**Public Hearing (9/19/12)  
General Waste Discharge Requirements for ASR Projects  
Deadline: 9/13/12 by 12 noon**

**Subject: Comments on Proposed Waste Discharge Requirements for Aquifer Storage and Recovery (ASR) Projects that Inject Drinking Water into Groundwater**

Subject: Comments on Tentative Order – Waste Discharge Requirements for East Bay Municipal Utility District, Bayside Groundwater Project, 2600 Grant Avenue, San Leandro, Alameda County

Figure 2

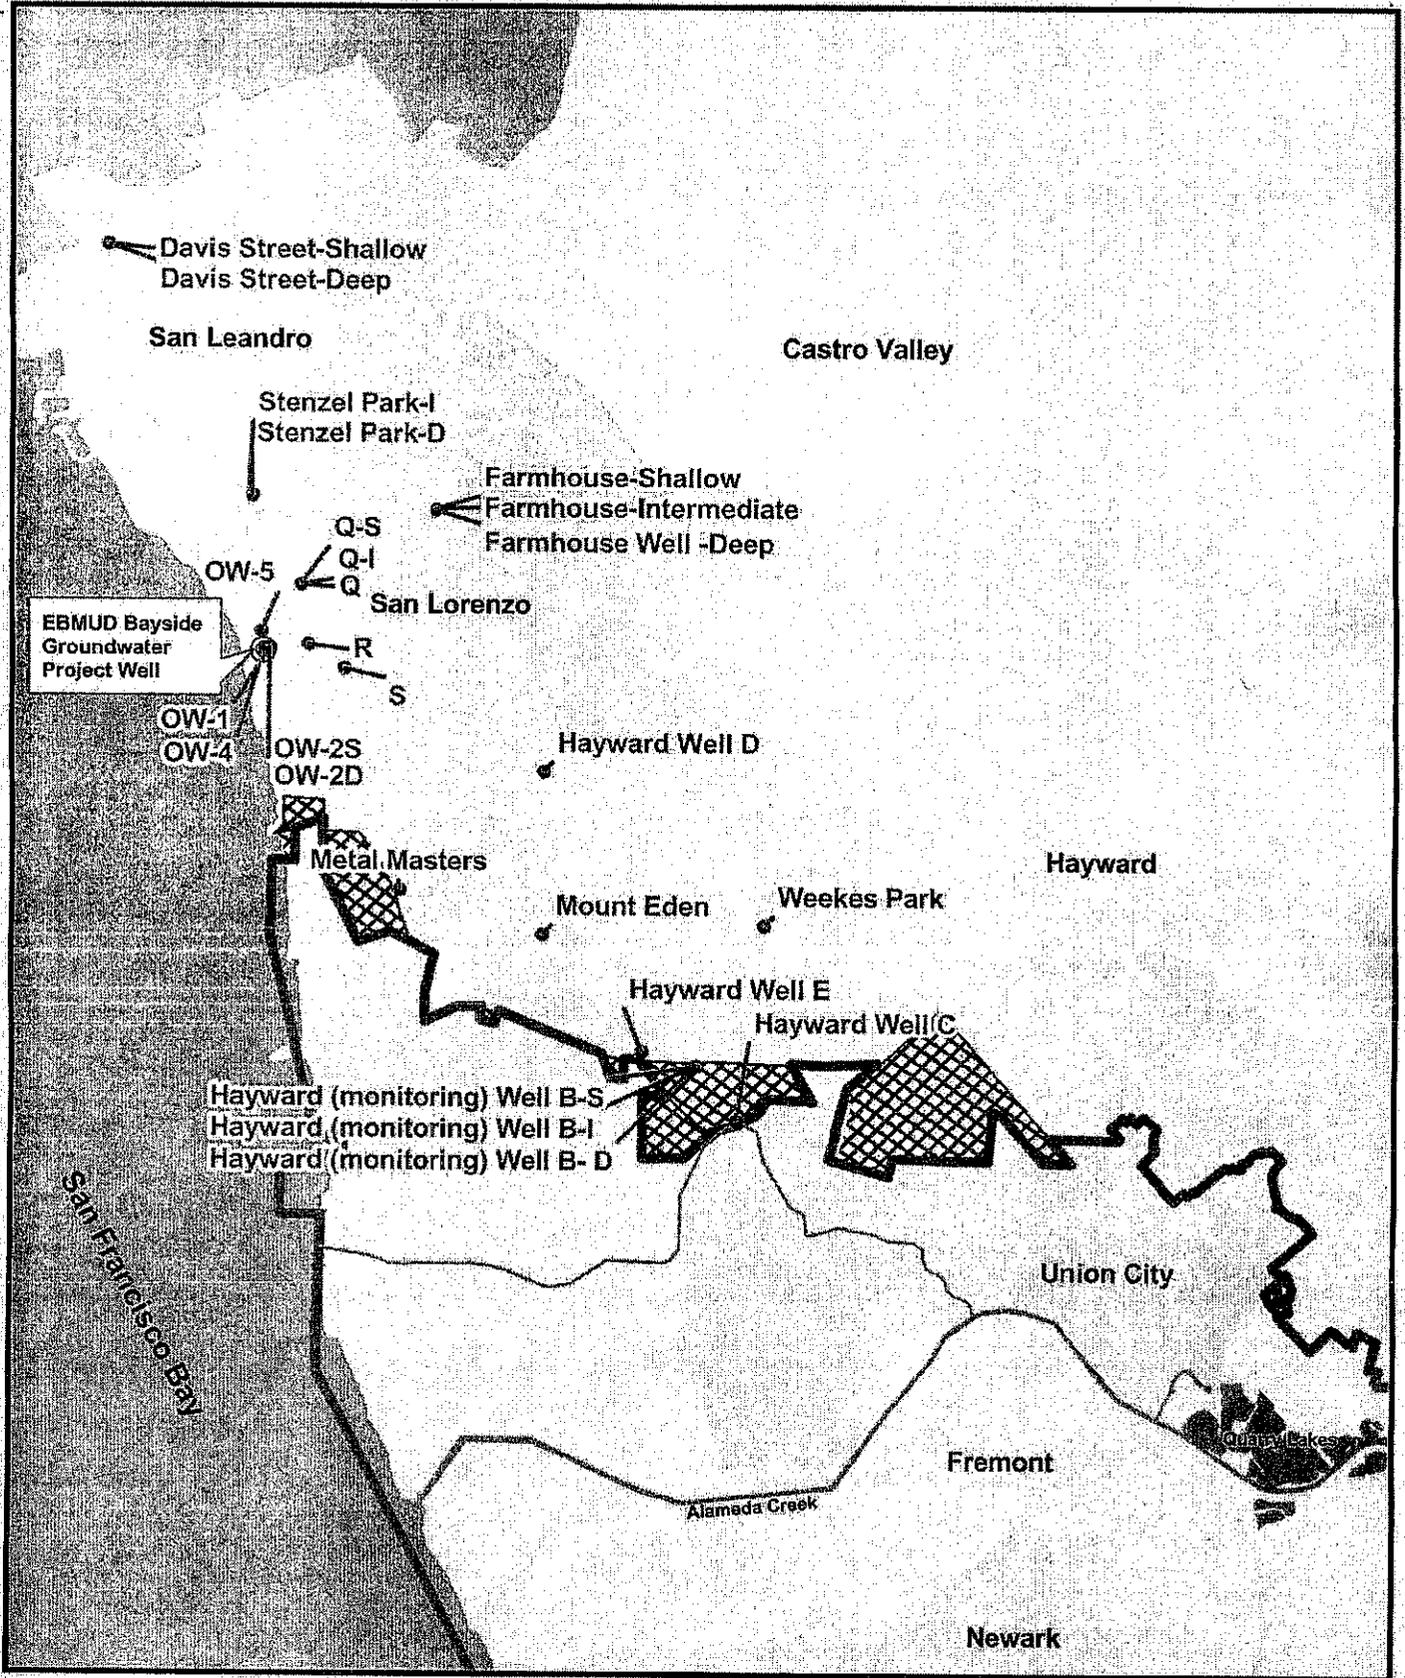
A. Monitoring of water levels in wells at regionally strategic locations and depths in the SEBP- not so much for focused evaluation of the Aquifer Storage Zone (although that is also an important objective) - but to enable verification of model assumptions affecting simulated vertical and horizontal flow within the SEBP on a basin-wide scale, because model-predicted impacts on the NCGB are sensitive to such assumptions. In previous communications with ACWD (most recent substantive communication was a meeting between ACWD and EBMUD staffs on March 28, 2006), EBMUD indicated its intent to measure water levels in a network of wells, including wells at locations greater than 5,000 feet from the Bayside site, for basin-wide model verification purposes and/or evaluation of aquifer response throughout the SEBP and within the transition zone between the SEBP and NCGB. Some of these wells appear in Table 1 within the Self Monitoring Program of Attachment A of the subject Tentative Order, but several, listed in the table below and indicated in the attached Figure 2, were left out:

<b>OMITTED MONITORING WELLS</b>		
<b>Well ID</b>	<b>Construction Status</b>	<b>Aquifer</b>
Davis Street-Deep	Existing	Deep
Davis Street-Shallow	Proposed new well	Shallow
Farmhouse-Shallow	Proposed new well	Shallow
Farmhouse-Intermediate	Proposed new well	Intermediate
Metal Masters	Existing	Shallow
Mount Eden	Existing	Deep
Weekes Park	Existing	Intermediate
Hayward (monitoring) Well B-Shallow	Existing	Shallow
Hayward (monitoring) Well B-Interm.	Existing	Intermediate
Hayward (monitoring) Well B- Deep	Existing	Deep
Hayward Well C	Existing	Deep
Hayward Well D	Existing	Deep
Hayward Well E	Existing	Deep

We request the language in the Order be modified to require monitoring of the these omitted monitoring wells (in addition to those already included in the Table 1 of Attachment A in the Self Monitoring Program), or an alternative network of wells that provide similar vertical and lateral coverage on a basin-wide scale, and that the monitoring of the network adhere to a schedule as follows:
